## ACCESS PLANNING REVIEW REPORT

PROJECT NAME: Wee Waa High School  
PROJECT STAGE: Concept Design – SSDA Stage  
PROJECT NO: GDL-210339  
PREPARED FOR: School Infrastructure NSW  
DATE: 29.10.2021

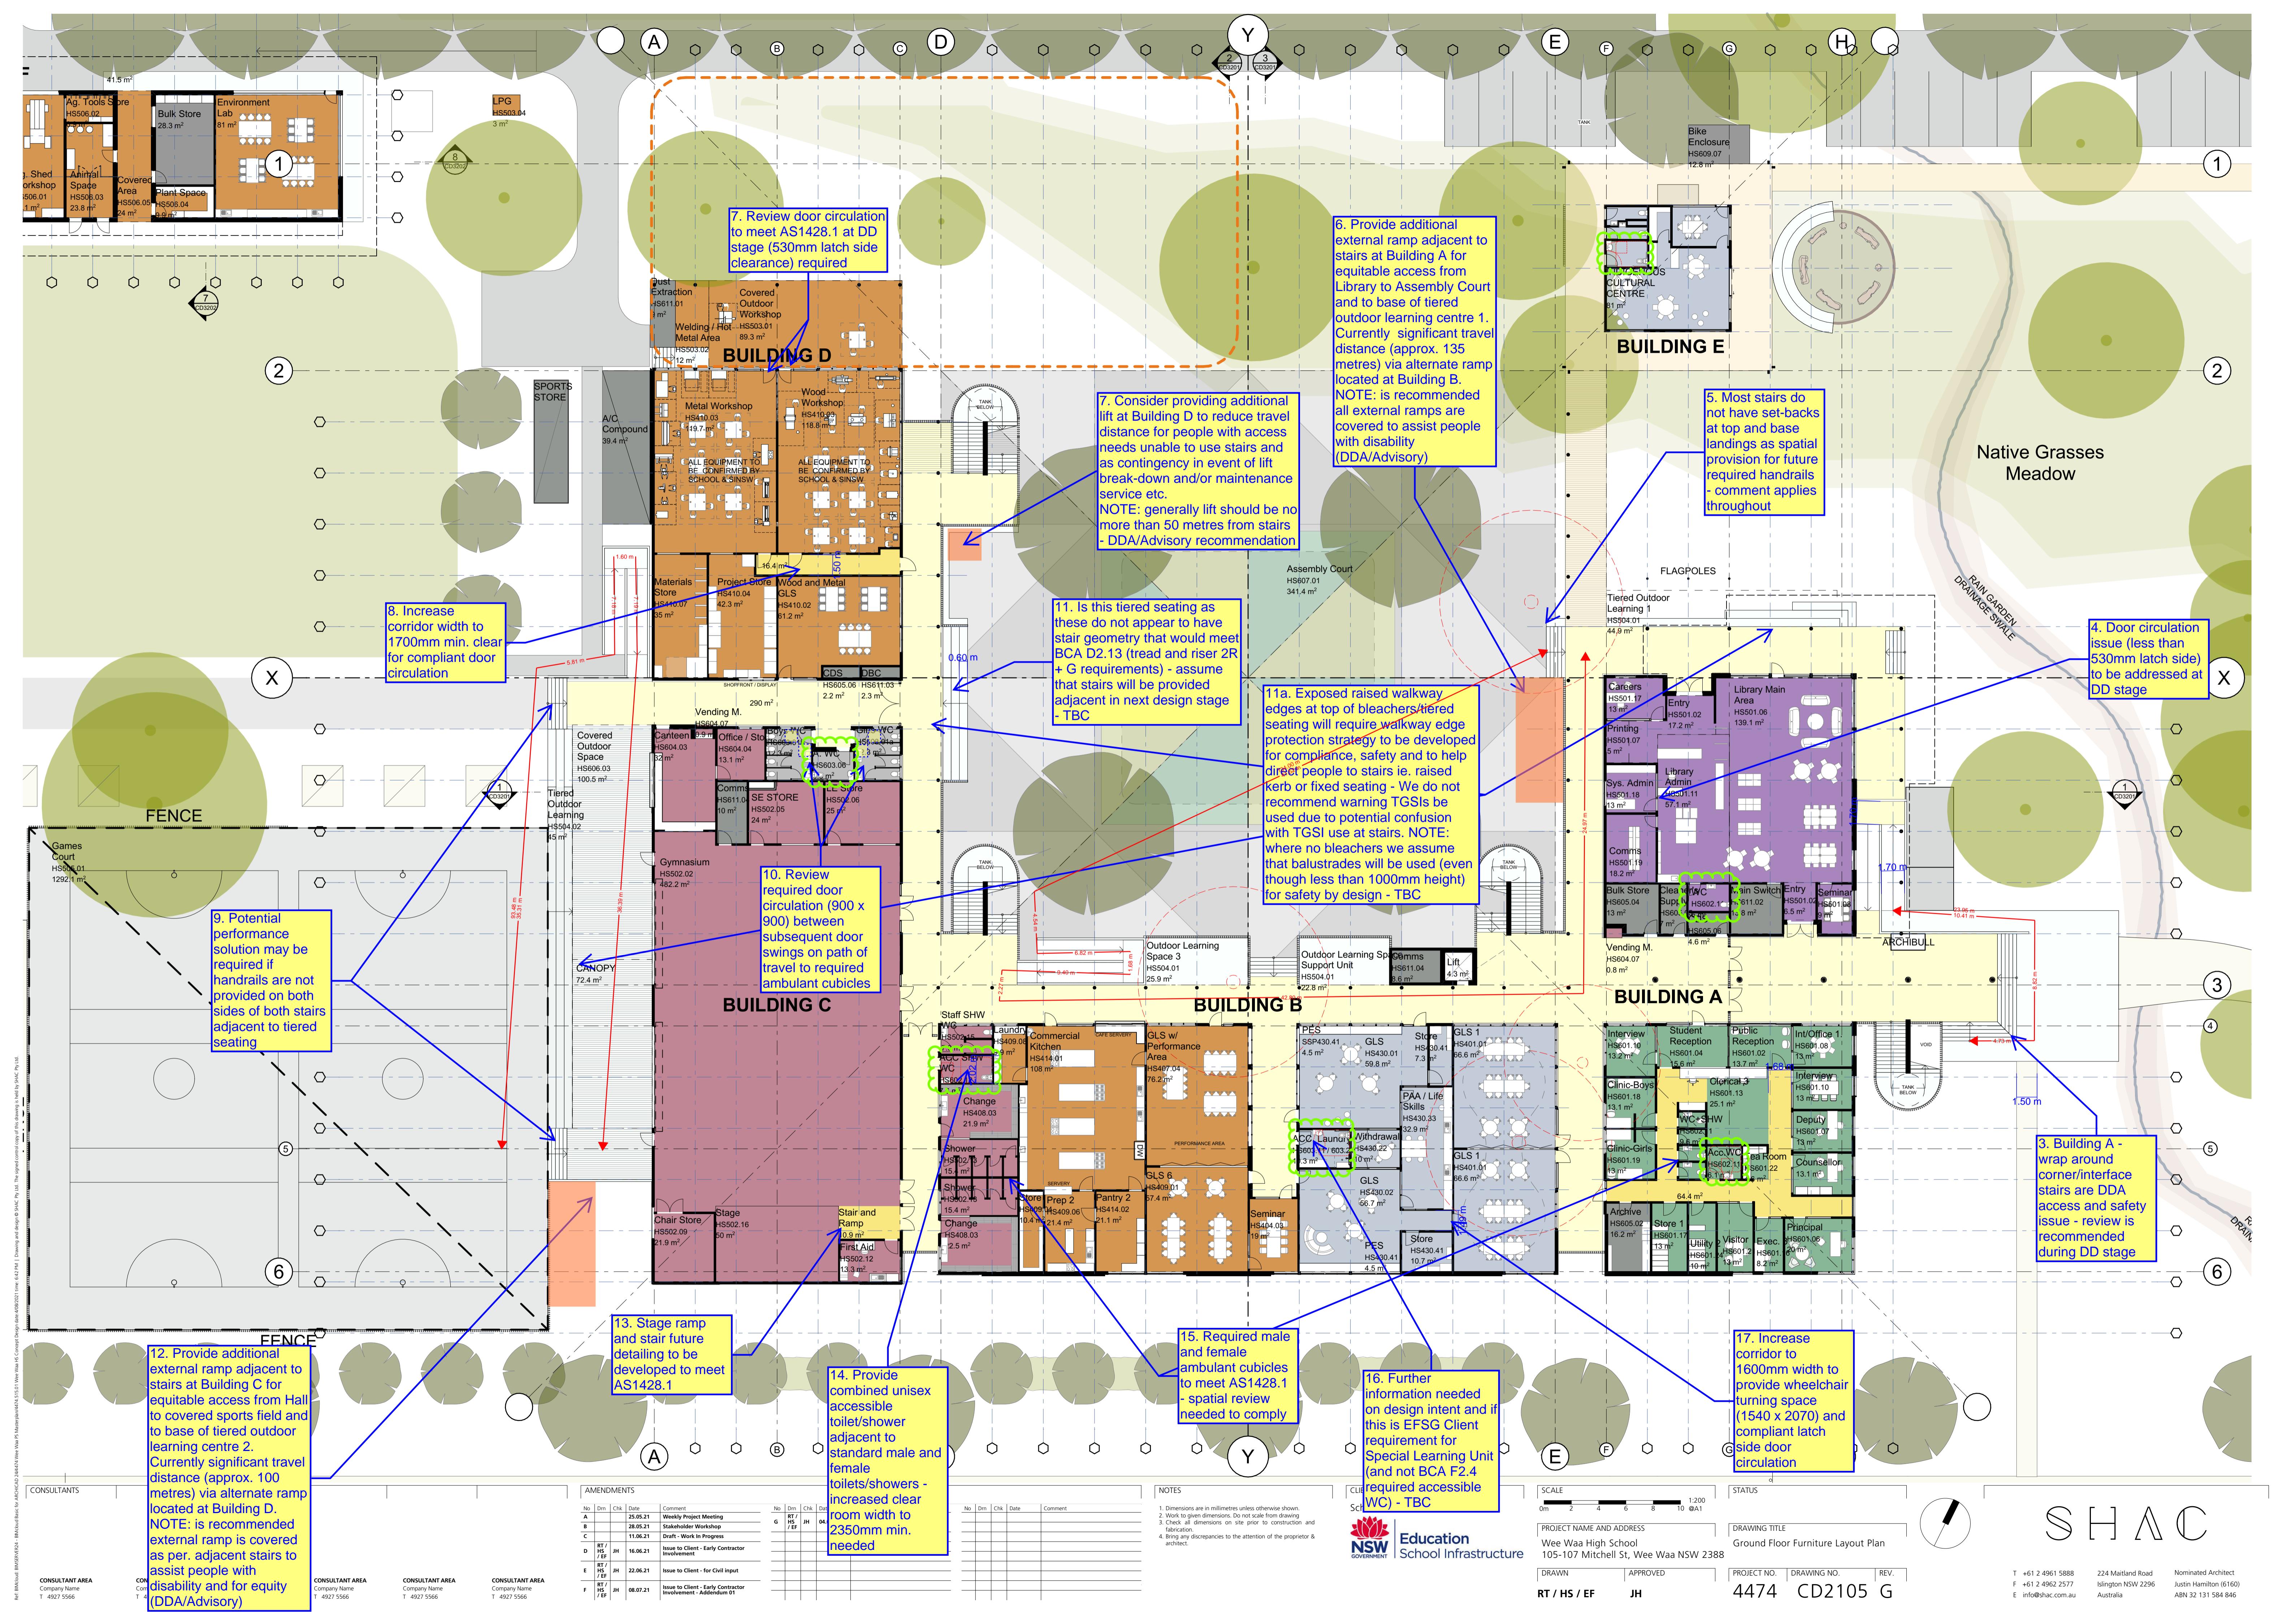
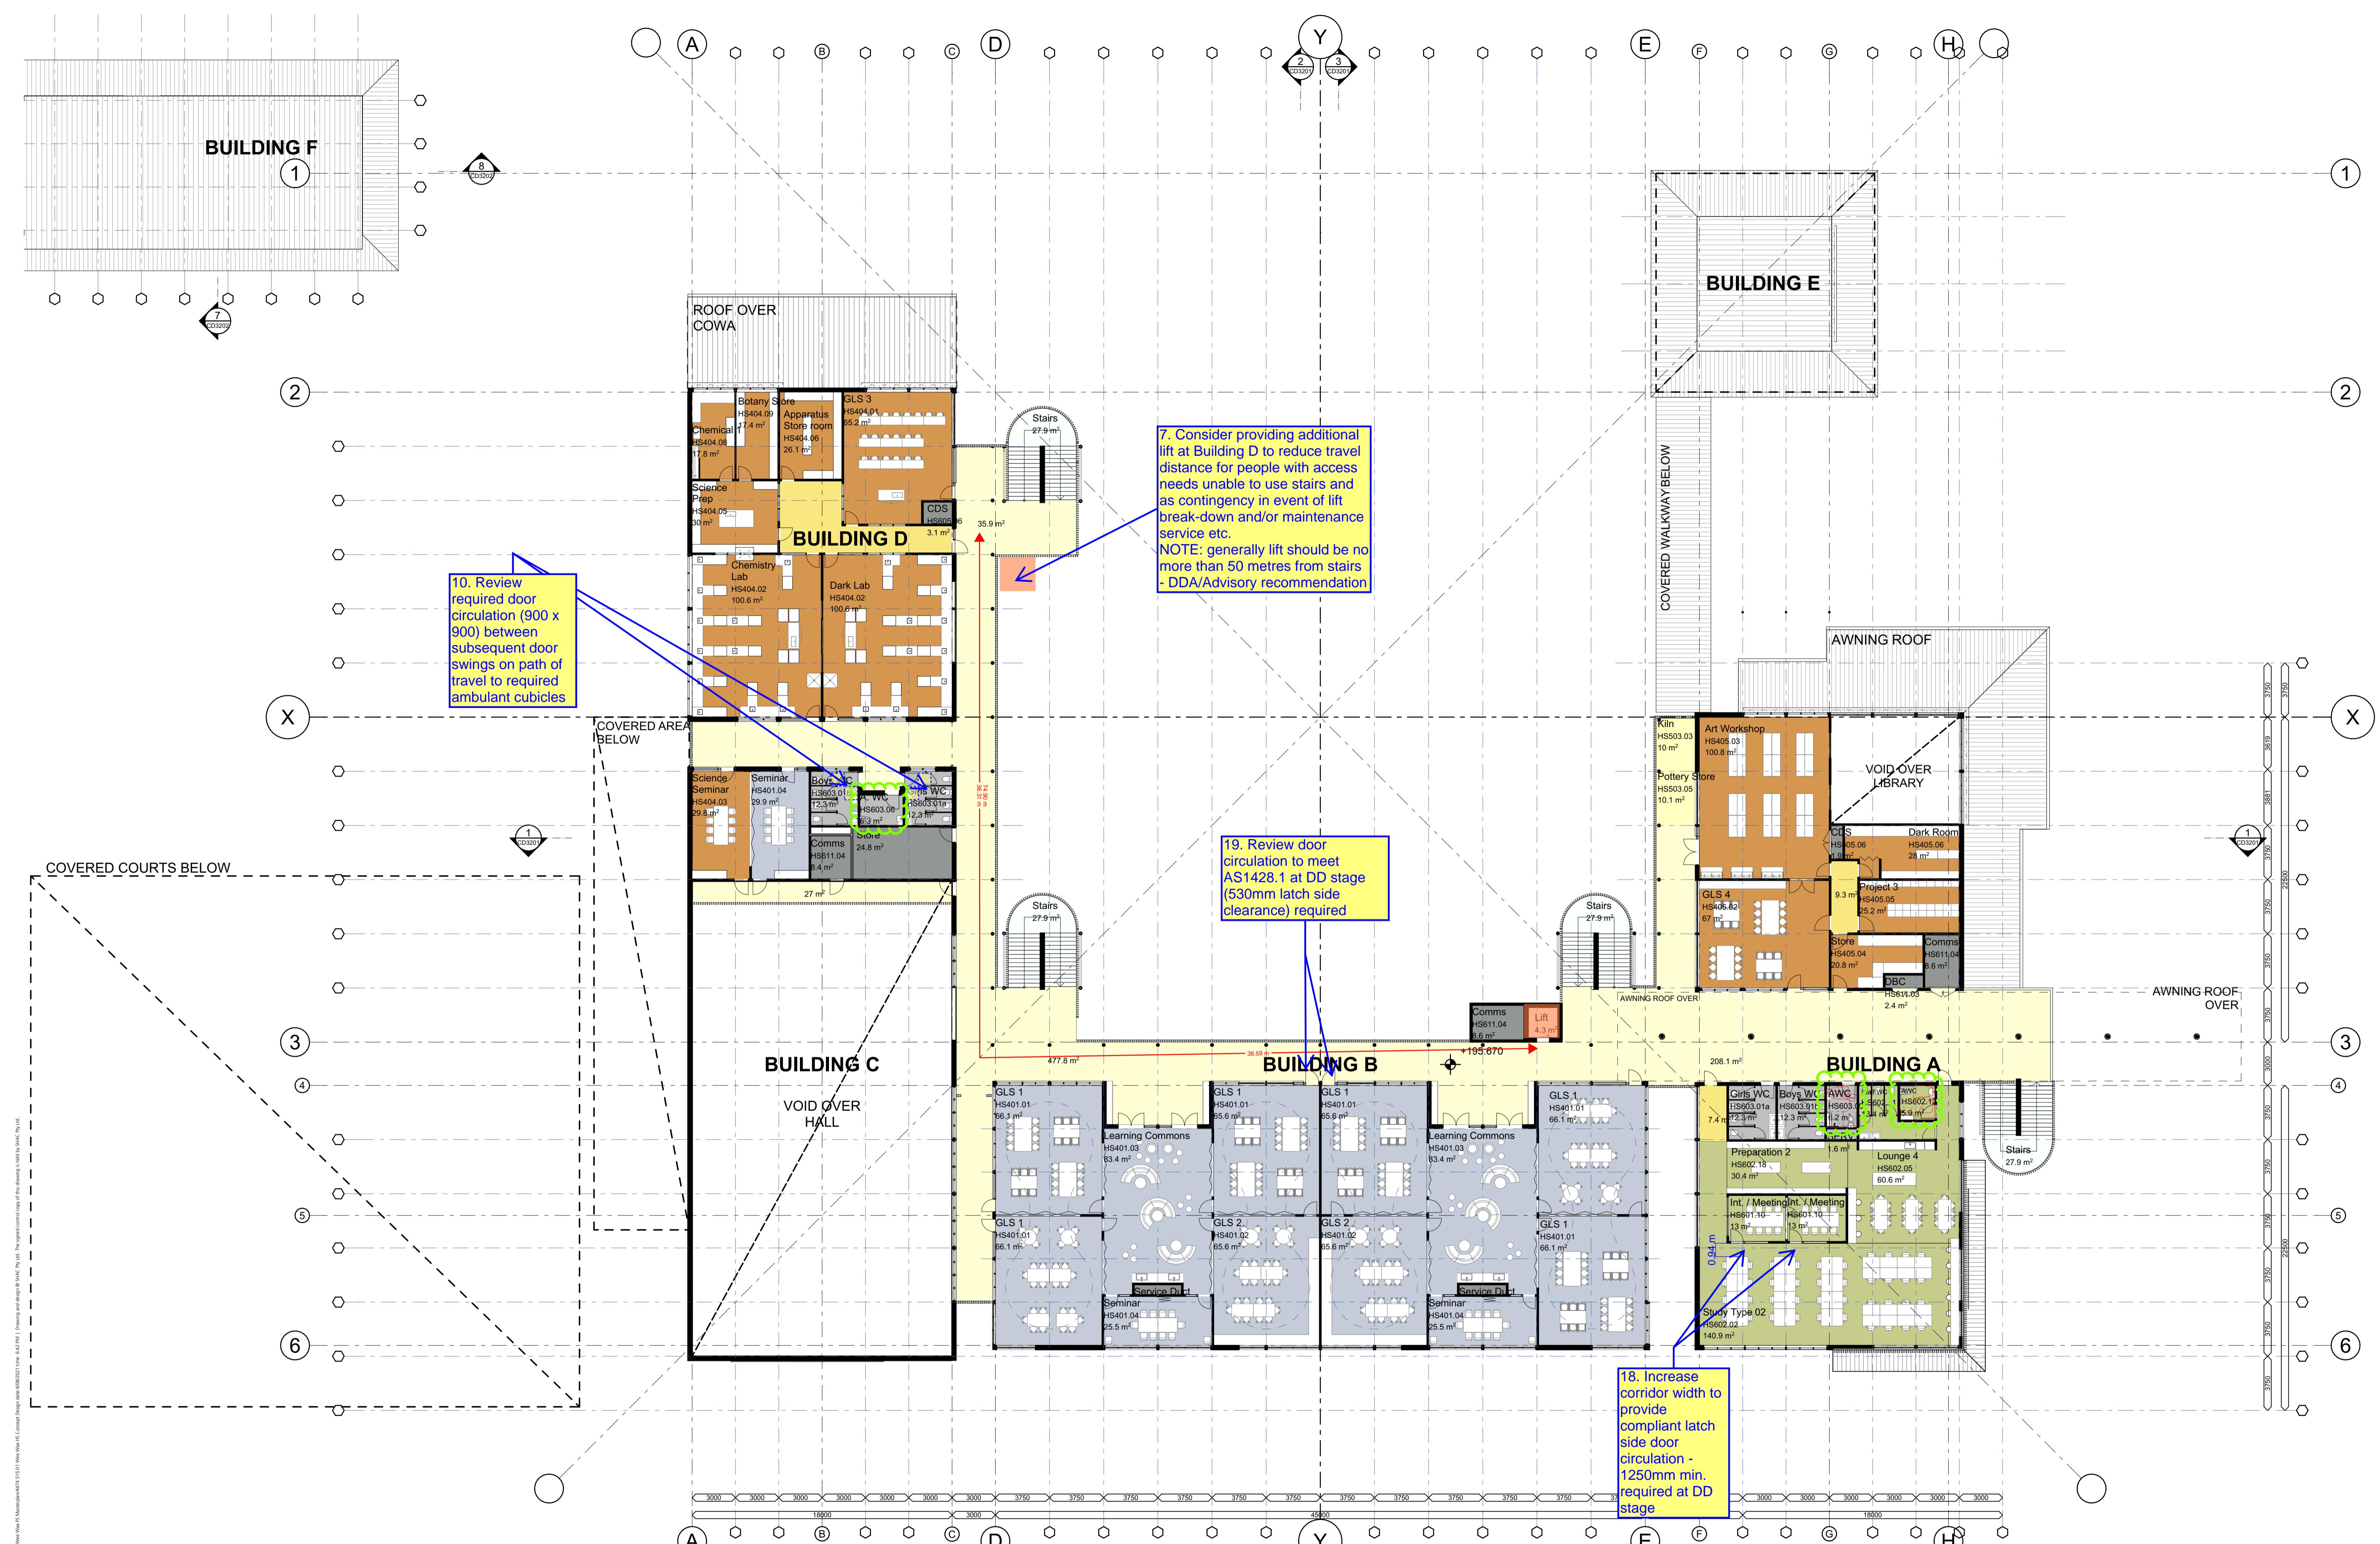
Further details of the proposed landscape design, including hardstand pedestrian pathway system to connect key outdoor areas of the school will be assessed during the next design stage. It is recommended that the above access recommendations are used during ongoing design development to maximise access, participation, and inclusion and to minimise risk of potential DDA complaints.

It should be noted that even where Open space and/or Sporting/Playing Field areas are proposed in grass/turf surfaces (not accessible) consideration of connecting pathways to dedicated viewing and/or partial engagement areas suitable for people with disability is highly recommended to meet the intent of the DDA.
